Engineering Bulletin #113 Failures on 3-Pole Plug-in Relays on Tricon Controllers

Tricon Plug-in Relay Failures

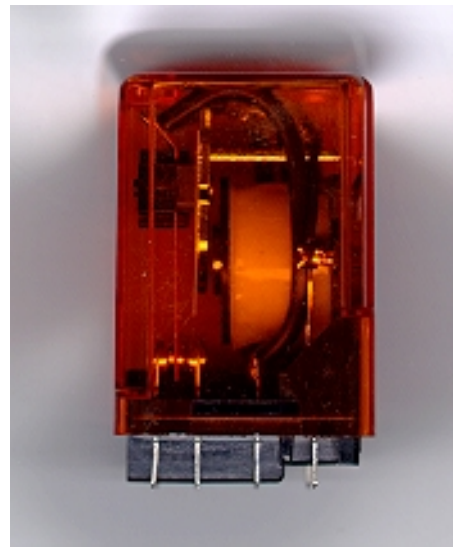
O. Thompson has experienced an unacceptable rate of failure on the 3-pole plug-in relays on the Relay Board of Tricon car controllers. The effected relays carry part number **EQU14D35F-DC110**. Not all relays with this number are effected, though. To determine if the relay needs to be replaced, look at the coil inside the relay. If the coil is white, the relay should be replaced. If the coil is black, the relay will work properly and does not need to be replaced. See the pictures below for identification of the effected relays.

O. Thompson will supply new relays at no charge to replace the existing relays. To order the replacement parts, please contact O. Thompson Technical Support at (718) 417-3131.
